Proposal #15: 2718-15-70, WISC 2020 043
Chinook Pass, Town of Waukesha
CTH ES to Les Paul Parkway
STH 164
Walworth County

This is Addendum No. 01, which provides for the following:

ADDENDUM NO. 01

Addendum No. 01
ID 2718-03-76
Deleted Sheet 16
January 30, 2020

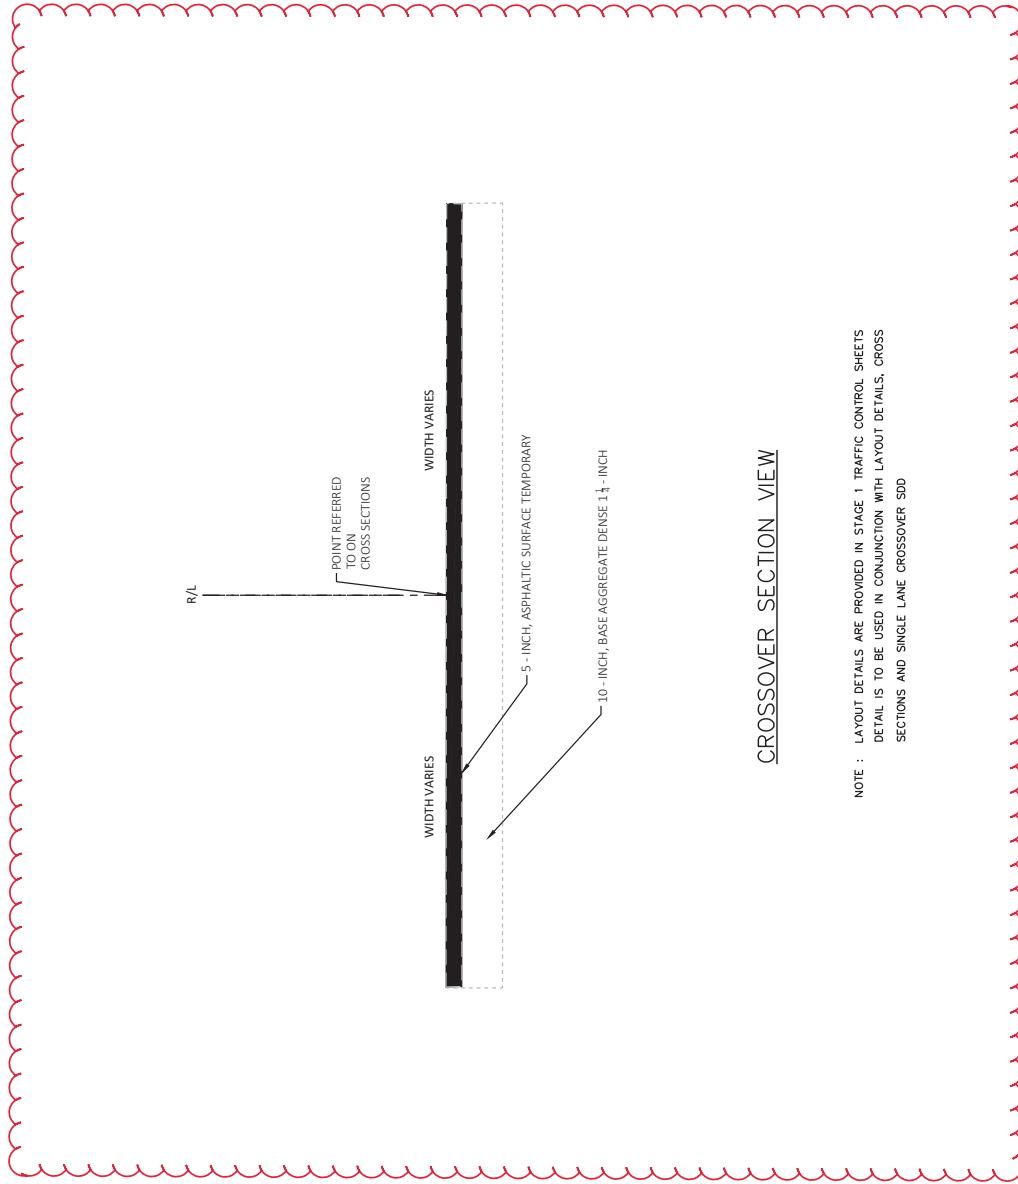
Deleted Plan Sheets	
Plan Sheet	Plan Sheet Title (brief description of why sheet was deleted)
16	Joint repair detail
524 - 528	Sheets not needed after crossover cross sections were revised

Addendum No. 01
ID 2718-03-76
Revised Sheet 17
January 30, 2020

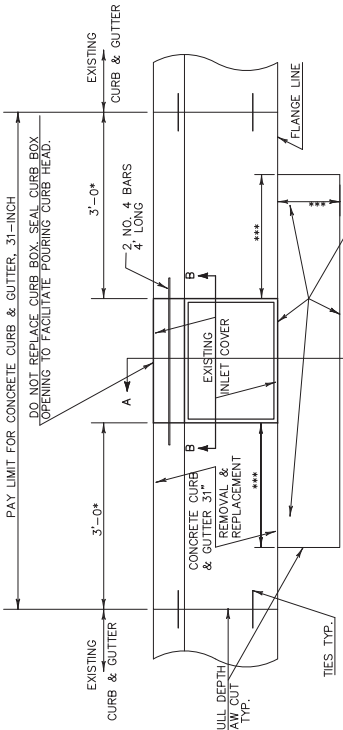
Revised Plan Sheets	
Plan Sheet	Plan Sheet Title (brief description of changes to sheet)
3	Added on utility contact (no conflicts) and eliminated 2 utility contacts
17	Eliminated Joint repair detail & added a detail showing HMA and Agg depths for crossover
18	Eliminated note concerning Milwaukee county
334	Updated MQ Sheet
493 thru 523	Revised crossover cross sections to provide a better depiction

CROSSOVER SECTION VIEW

NOTE : LAYOUT DETAILS ARE PROVIDED IN STAGE 1 TRAFFIC CONTROL SHEETS
DETAIL IS TO BE USED IN CONJUNCTION WITH LAYOUT DETAILS, CROSS
SECTIONS AND SINGLE LANE CROSSOVER SDD
